## RE: Transmission costs for the 2022 Integrated System Plan

Shell Energy Australia Pty Ltd (Shell Energy) welcomes the opportunity to respond to the Australian Energy Market Operator (AEMO) consultation on the Draft Transmission Cost Report (DTCR), which will inform the 2022 Integrated System Plan (ISP).

Figure 1: Comparison of mid-point and high-range cost estimates

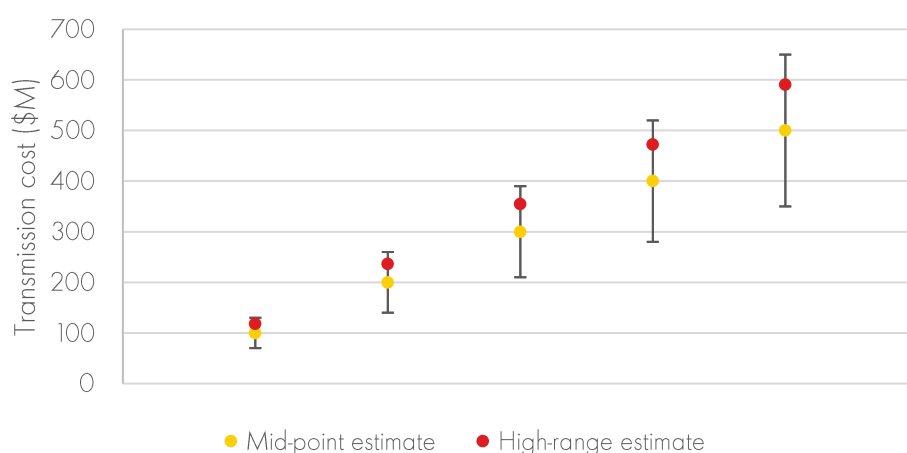
It would be relatively easy to implement a high-range cost estimate with an asymmetric error margin such that the error bounds remained the same. The simplest method would be to linearly rescale the final TCD output for any given network option. As an example, if a cost estimate is  $x \pm 30\%$  (or equivalently  $0.7x < \text{cost} < 1.3x$ , with a mid-point estimate of  $x$ ), then a high-range estimate,  $y$ , with an upper uncertainty of  $+10\%$  would be calculated as  $(1 - \frac{53}{130})y < \text{cost} < \frac{11}{10}y$ , where  $y = \frac{13}{11}x$ . Figure 1 illustrates how this would impact the cost estimates for different-sized projects.
